# Stormwater Division

**Stormwater Management/BMP Facilities  
Record Drawing/Construction Certification  
Review Tracking Form**

County Plan No.: S-30-97  
 Project Name: Stonehorse Sec 4A Leatherleaf BASIN G  
 Stormwater Management Facility: BASIN G Dry Pond 2924 Leatherleaf Drive

Re: Stonehouse Section 4A Leather Leaf, Basin G  
Dry Pond at Road near 2924 Leather Leaf  
County BMP ID Code: WC 039

RECORD DRAWING  
OF  
BASIN G  
SECTION IVA  
AT STONEHOUSE

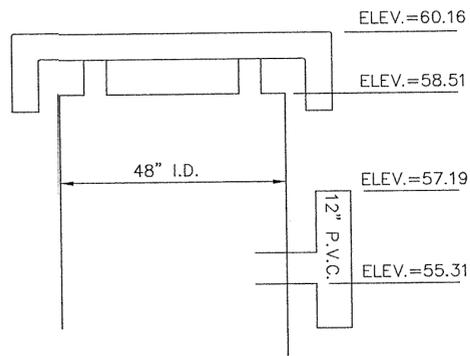
2. Add the detention basin outlet structure detail as provided on Sheet 11 of the approved plan set to the as-built (record) drawing for the facility. This detail provides important information about the facility. Annotate the detail as necessary with field-obtained construction information.
3. Show the following additional information on the record drawing: topography along the west side of the basin; size of riser; size of the higher level (dewatering) orifice; and street address on Lot 7 as 2924 Leather Leaf Drive.
4. If possible, add the following County identifiers to the lower right hand corner of the record drawing: County Plan No. S-30-97 and BMP ID No. WC 039.

REVISED PER COUNTY COMMENTS: 2/25/03
